CITY OF West Linn

STAFF REPORT FOR THE PLANNING COMMISSION

FILE NUMBER: DR-23-01

REQUEST: The applicant is requesting approval for the demolition of two existing structures, to be replaced with a two-story commercial building with underground parking and a rooftop deck at 1919 and 1949 Willamette Falls Drive.

1 GROUND FLOOR PLAN + WILLAMETTE FALLS DRIVE ELEVATION

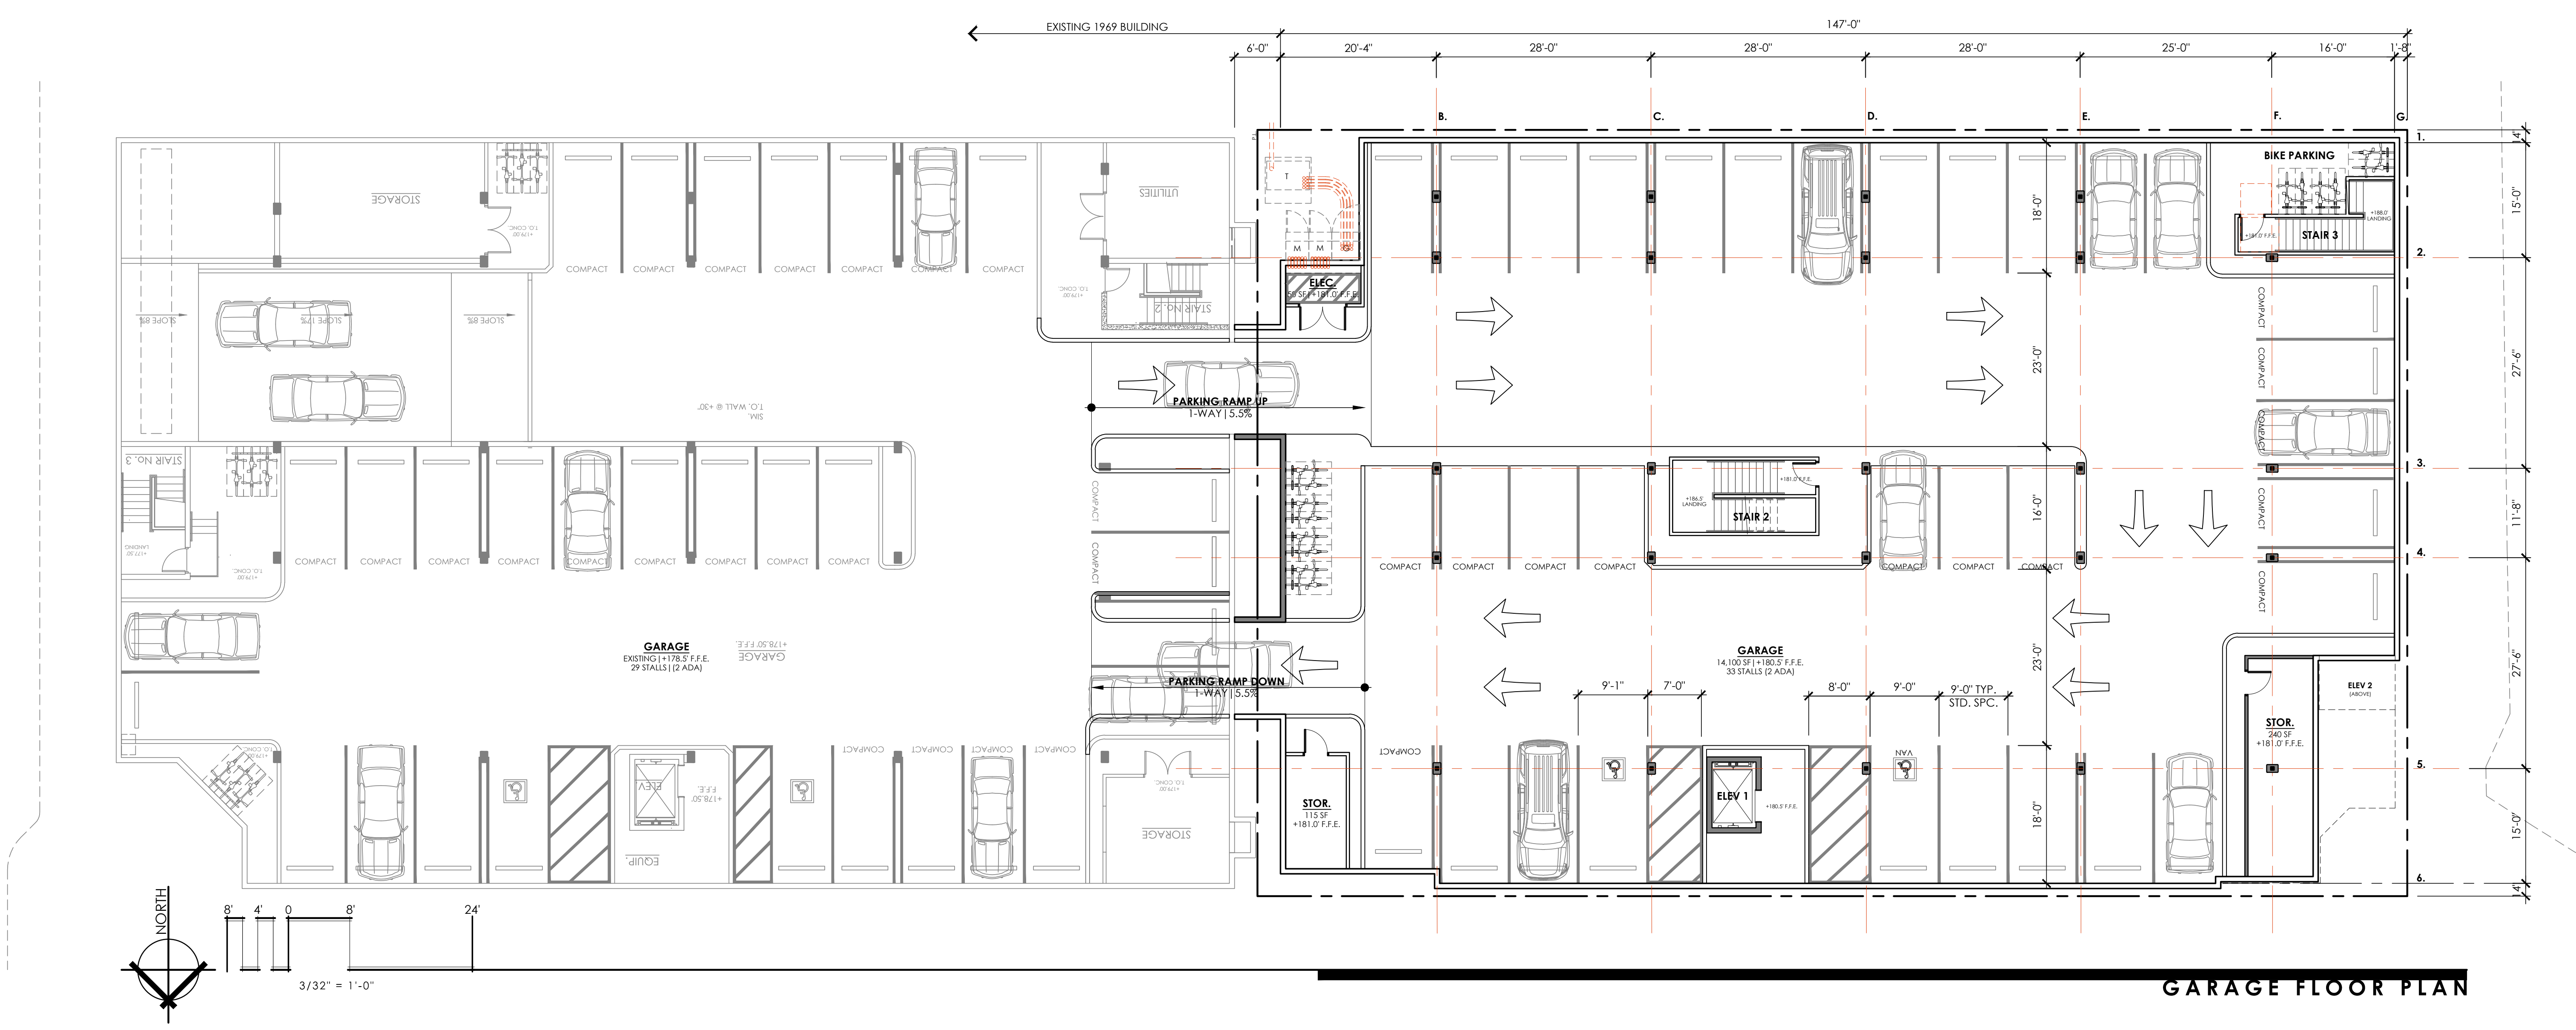
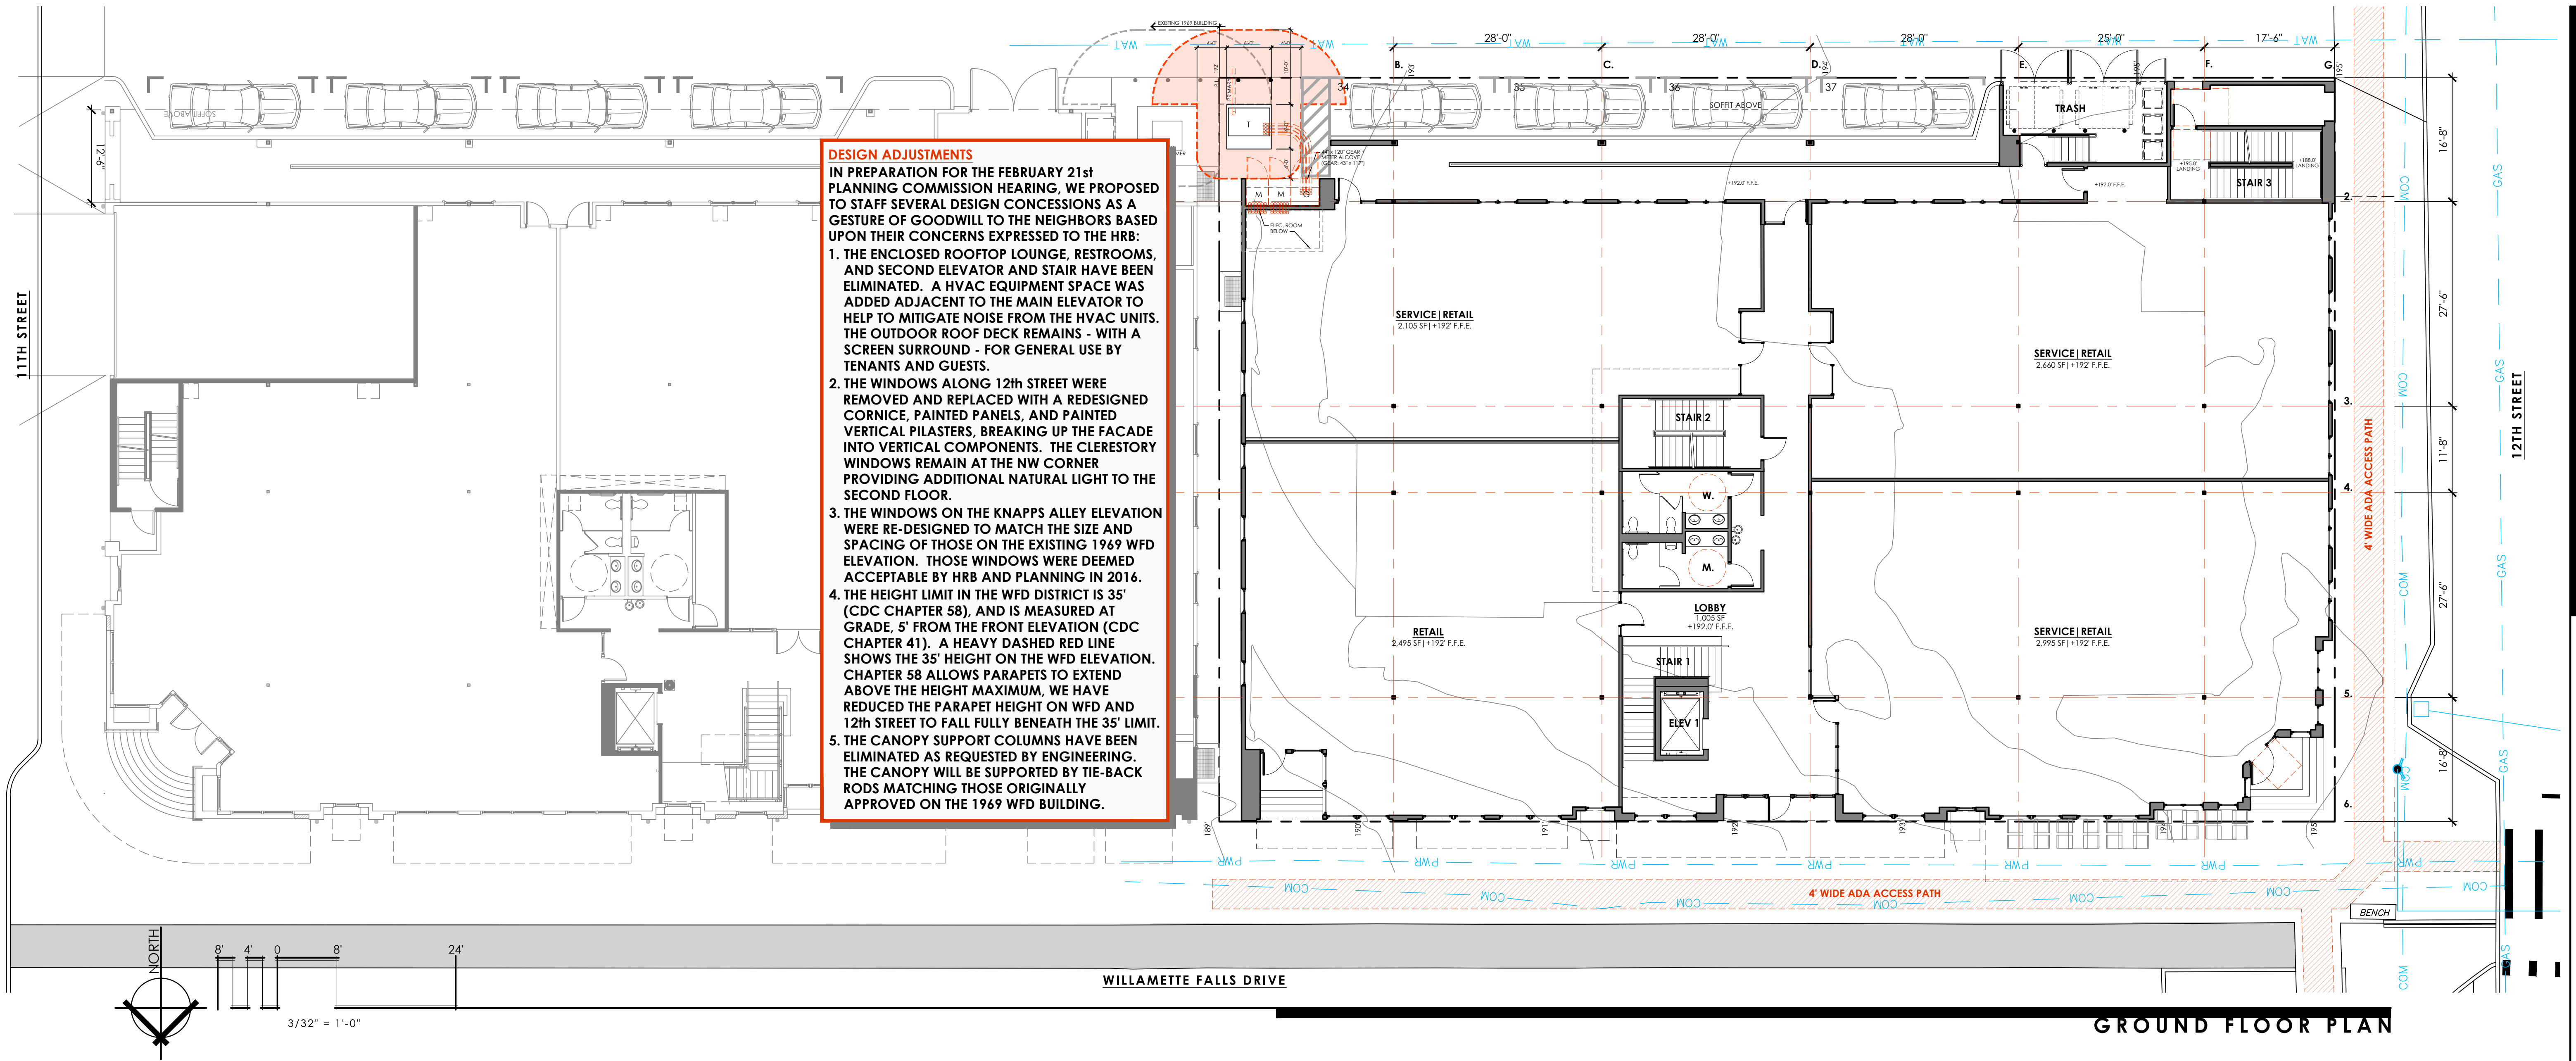
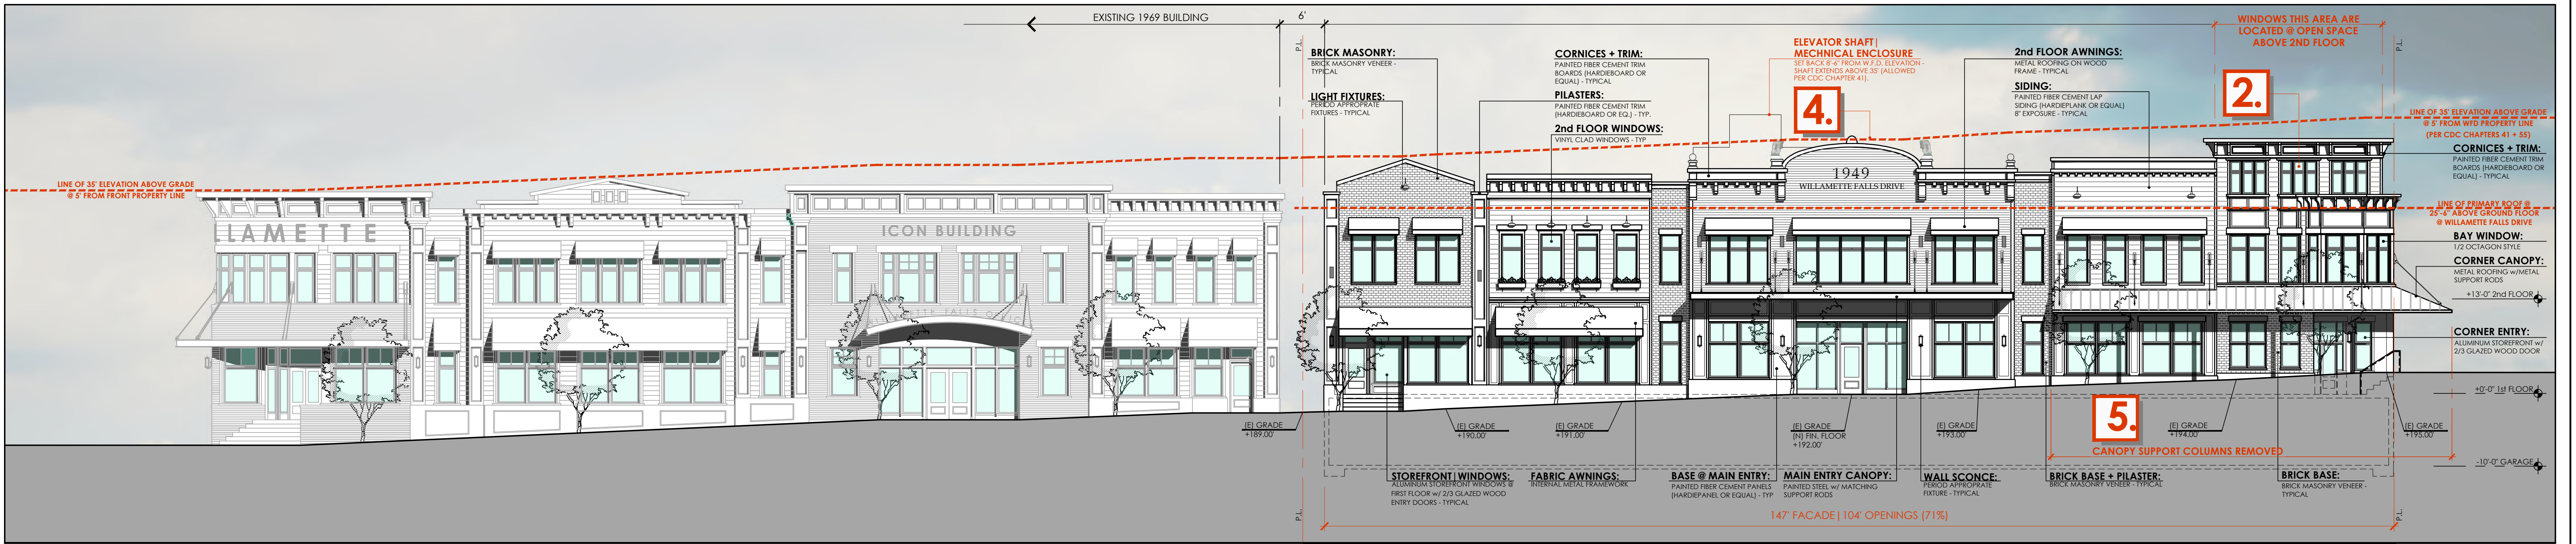
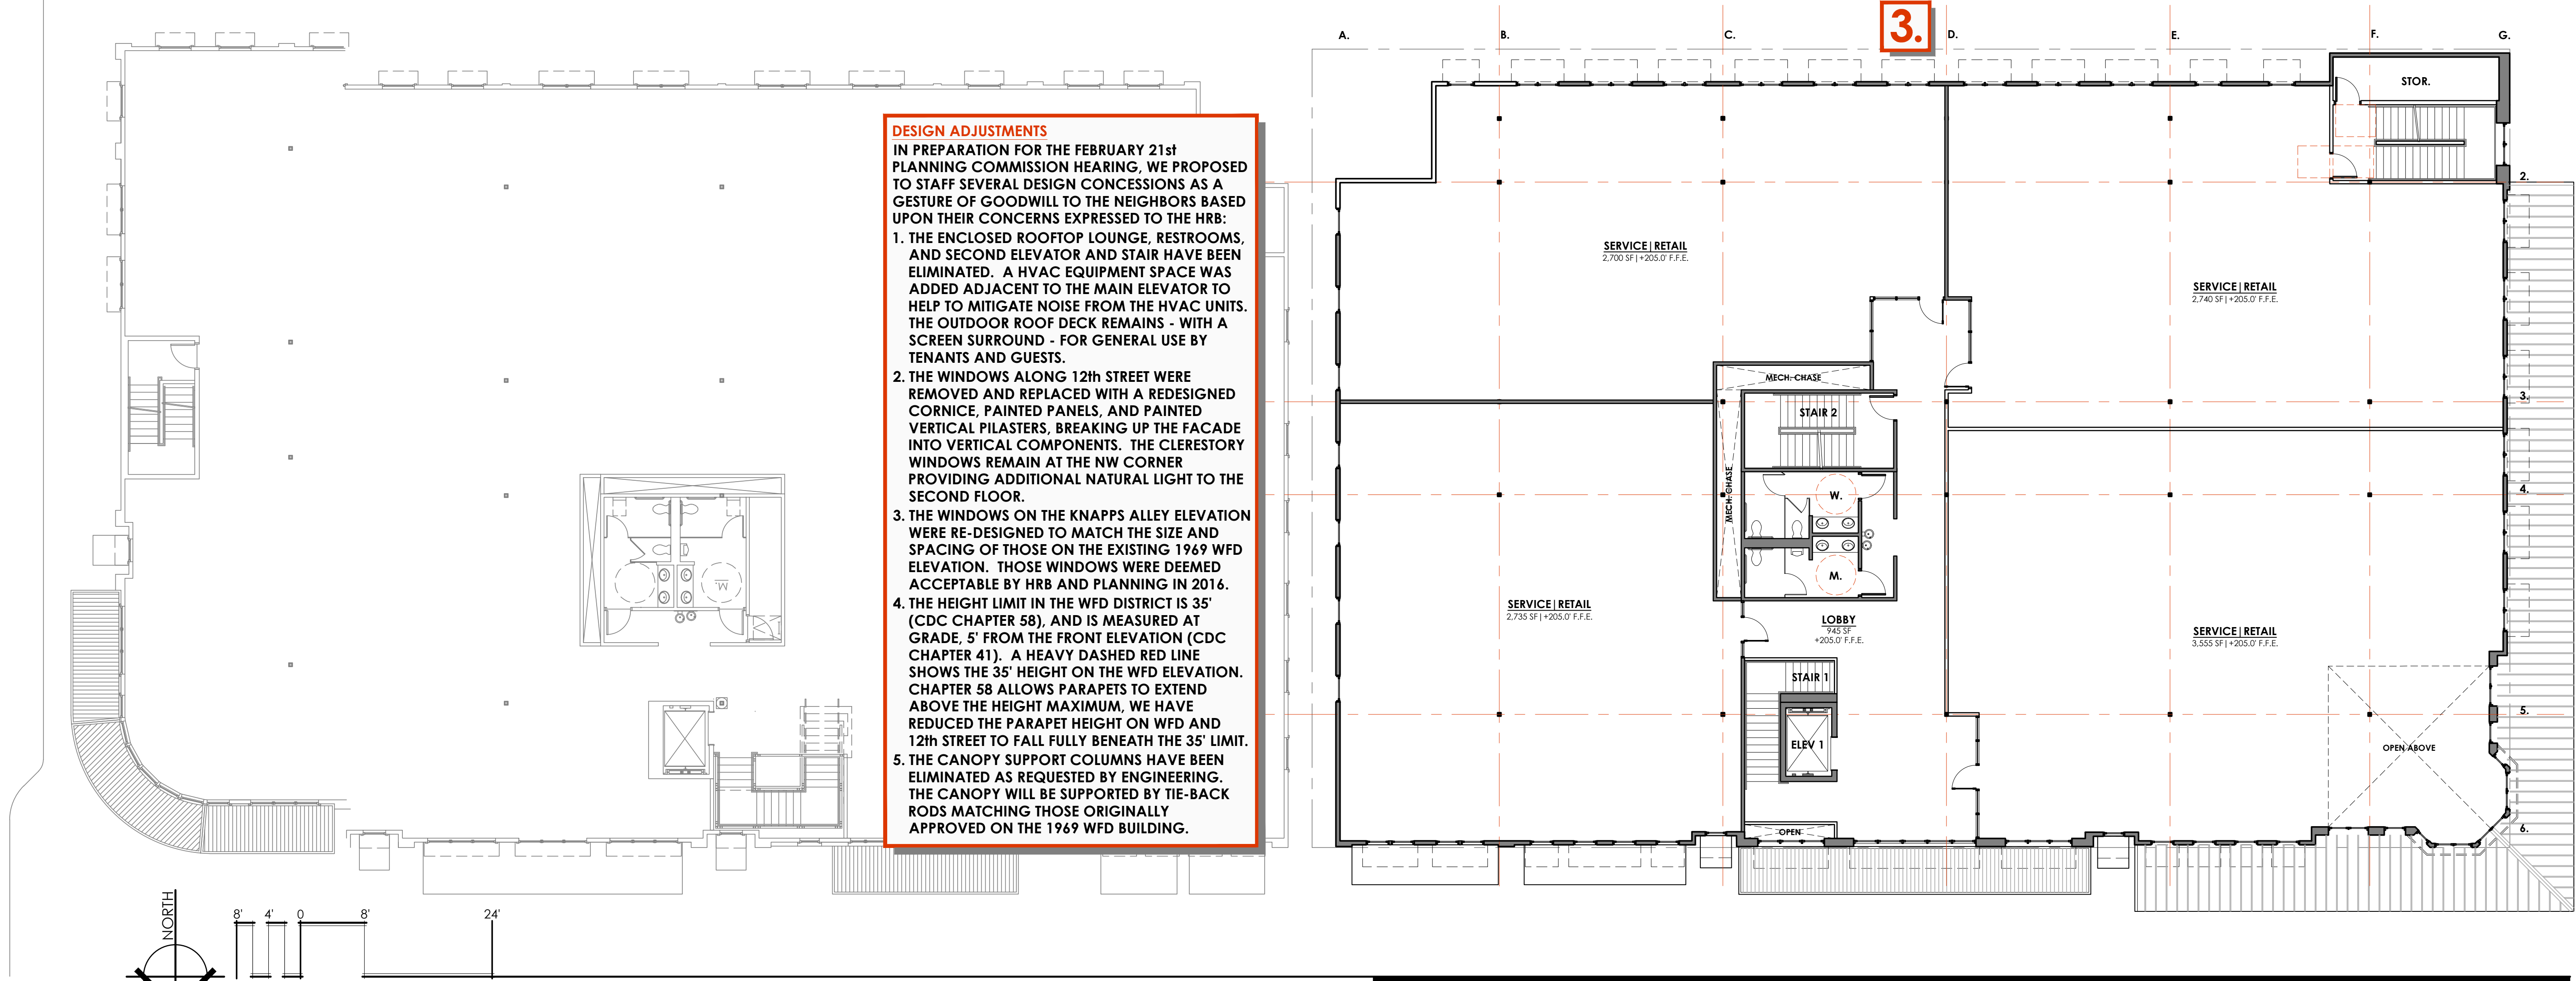
1. THE ENCLOSED ROOFTOP LOUNGE, RESTROOMS, AND SECOND ELEVATOR AND STAIR HAVE BEEN ELIMINATED. A HVAC EQUIPMENT SPACE WAS ADDED ADJACENT TO THE MAIN ELEVATOR TO HELP TO MITIGATE NOISE FROM THE HVAC UNITS. THE OUTDOOR ROOF DECK REMAINS - WITH A SCREEN SURROUND - FOR GENERAL USE BY TENANTS AND GUESTS.

2. THE WINDOWS ALONG 12th STREET WERE REMOVED AND REPLACED WITH A REDESIGNED CORNICE, PAINTED PANELS, AND PAINTED VERTICAL PILASTERS, BREAKING UP THE FACADE INTO VERTICAL COMPONENTS. THE CLERESTORY WINDOWS REMAIN AT THE NW CORNER PROVIDING ADDITIONAL NATURAL LIGHT TO THE SECOND FLOOR.

5. THE CANOPY SUPPORT COLUMNS HAVE BEEN ELIMINATED AS REQUESTED BY ENGINEERING. THE CANOPY WILL BE SUPPORTED BY TIE-BACK RODS MATCHING THOSE ORIGINALLY APPROVED ON THE 1969 WFD BUILDING.
